Planning Commission Regular Meeting

The Planning Commission considered an application for a Residential Review Permit and variance application for 202 Oak Street at their January 26, 2026 meeting. The item was continued to the February Planning Commission meeting. The attached Staff report accompanied the application. The applicant has submitted revised plans. Staff has revised the Staff Report to analyze the revised plans. Staff revisions to the Staff Report are in italics.

Excelsior Good Neighbor Guidelines PLAN Review

updated/revised 02/19/2026

5. Consider front porch element in design of new structures	• Use an unenclosed single story front porch to break up a structure's massing on the street face.
--	--

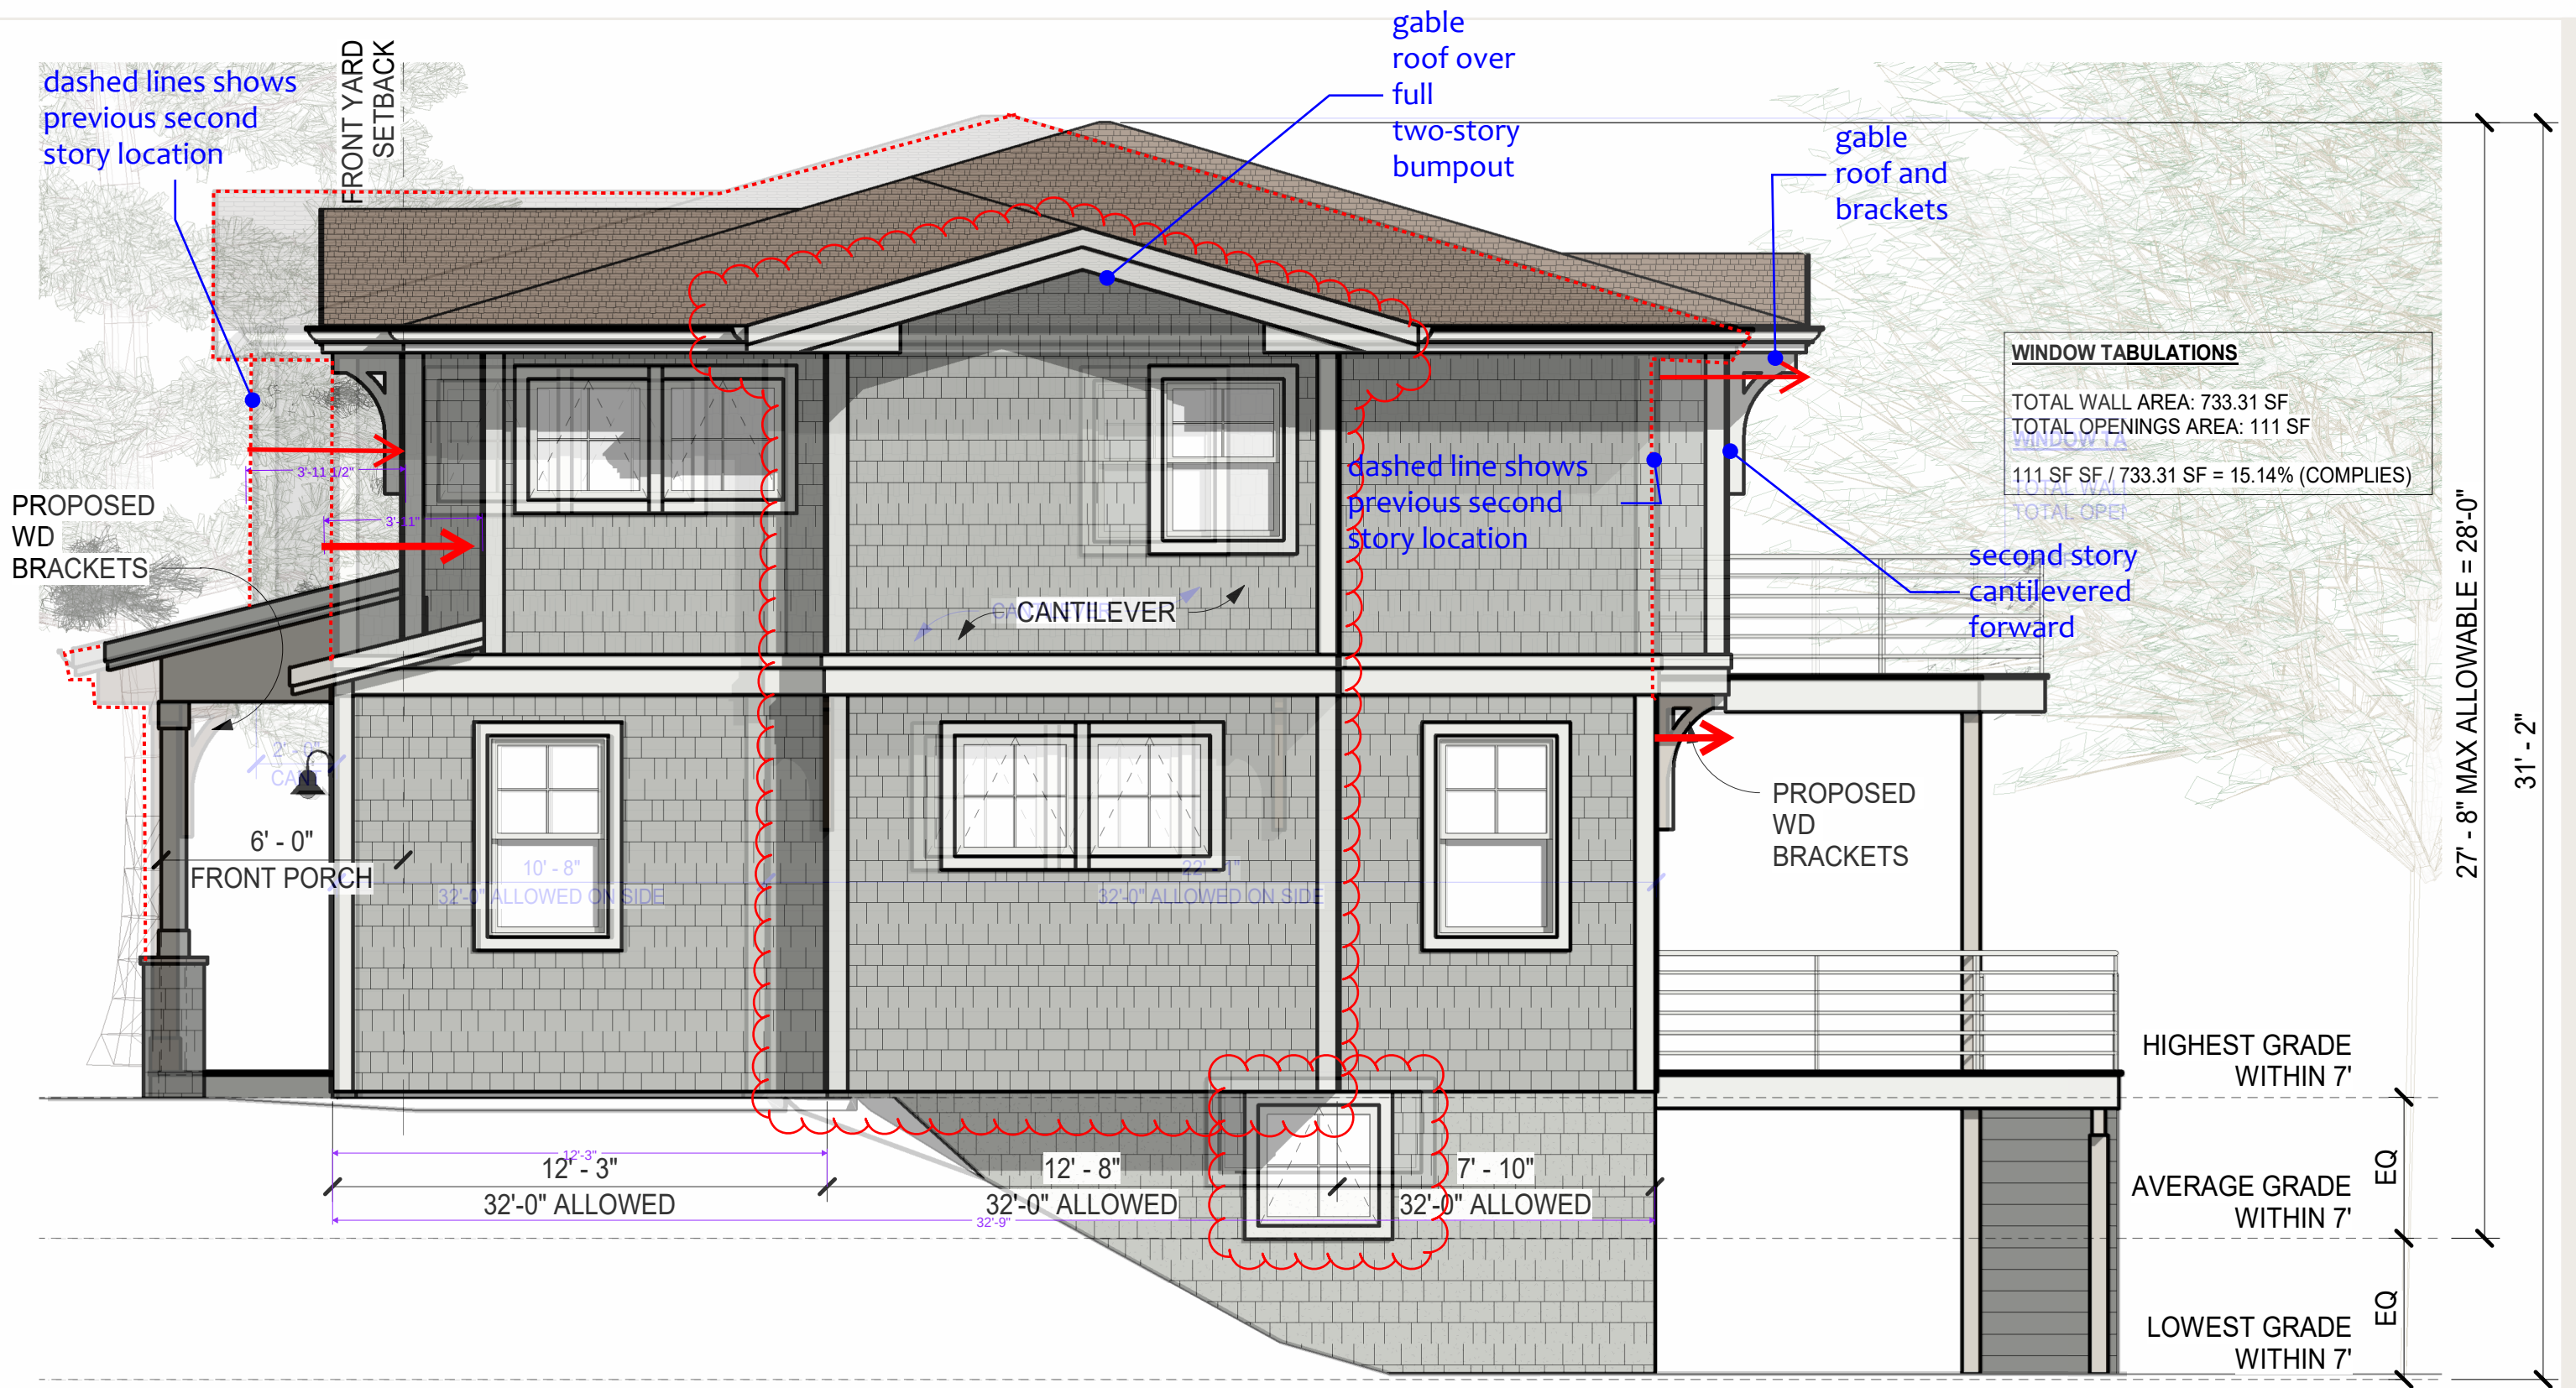
The proposed new 4-8 deep x 15-9 entrance porch frames a new entrance facing Oak Street (previous was an understated entrance facing the access driveway). This is an improvement to the public street face of the house and it helps to break up the two story massing, though it encroaches further on the front yard setback. *Revisions in this 02/26 submission show a simplified front porch that has the upper level pushed back to align with the wall plane below, which is an improvement. Applicant shows two possible options for porch, with and without columns. From a massing standpoint either appear acceptable, with a preference for Option A with columns.*

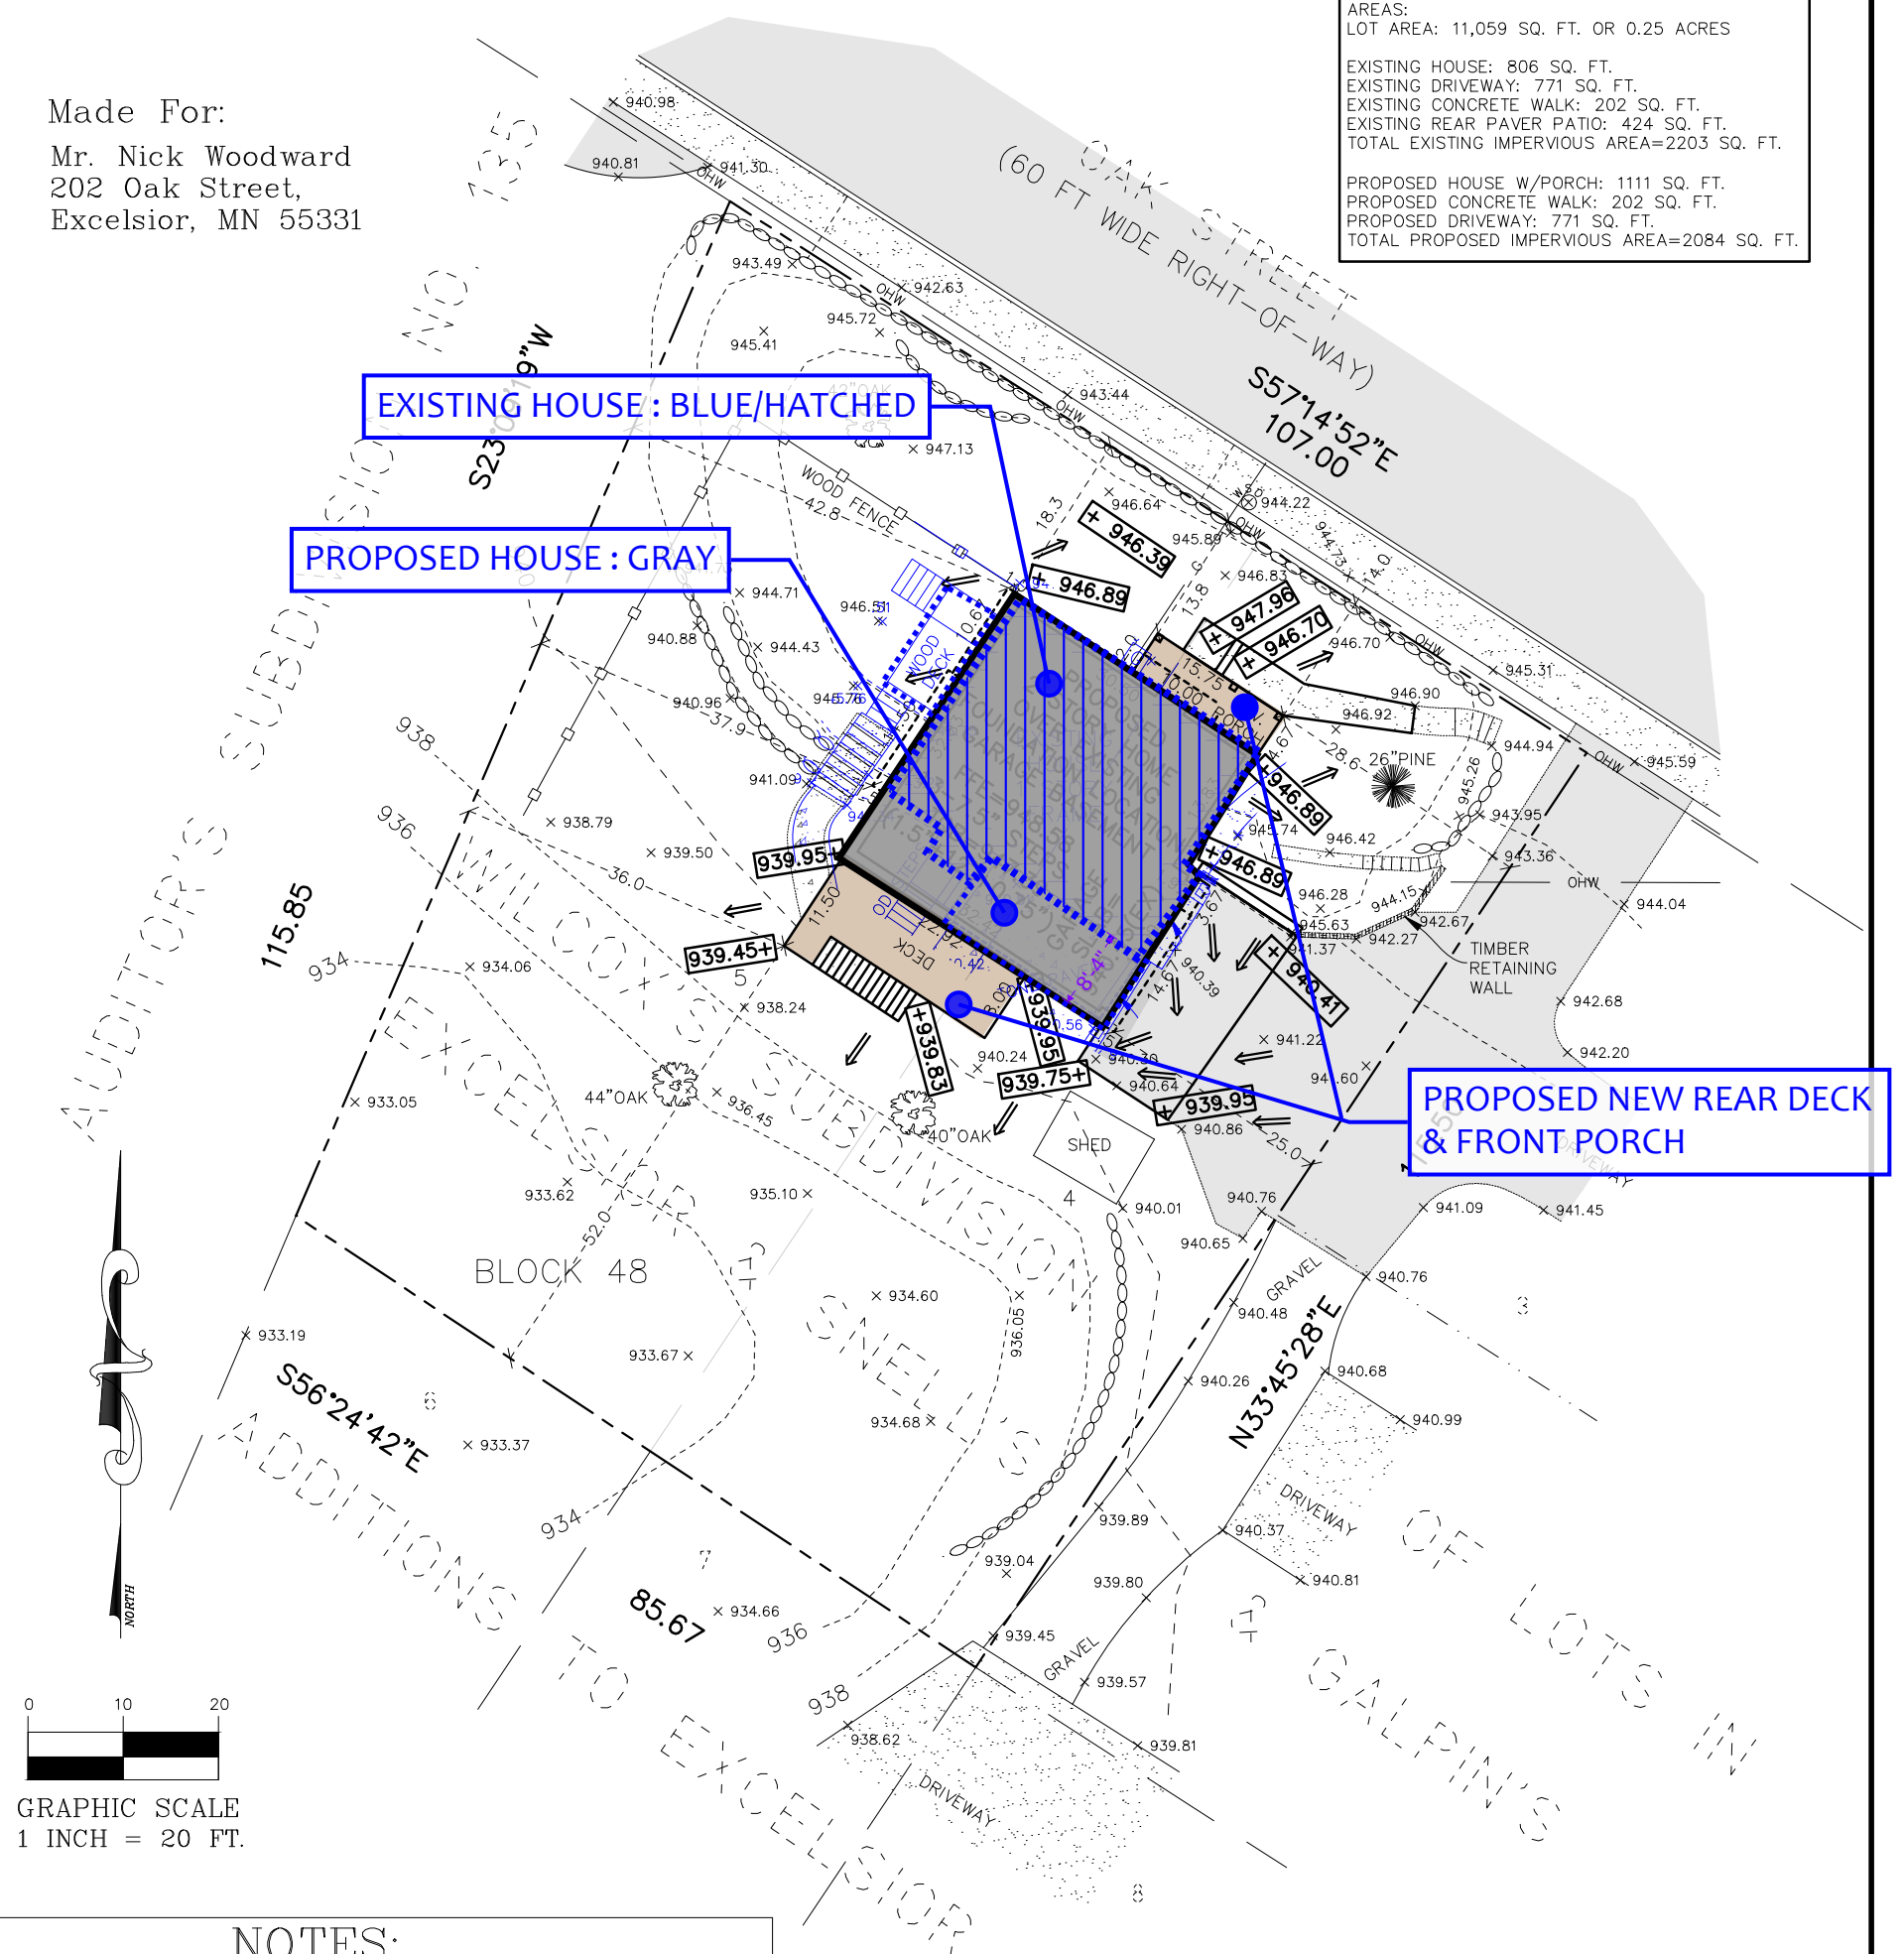
The existing house at 202 Oak Street is a one-story rambler that becomes two stories at the rear and sides due to grade slope and elevation change. The project proposes all new construction on the existing foundation, expanding the footprint at the rear (about 33-6 x 8-4) with a full second floor throughout. The footprint location of the house remains substantially the same at front except for a new 4-8 deep x 15-9 entrance porch. The shared side access, tuck-under garage location remains; the rear expansion provides an additional second stall there. ***See attached overlay sketch on site survey illustrating existing and new additions.***
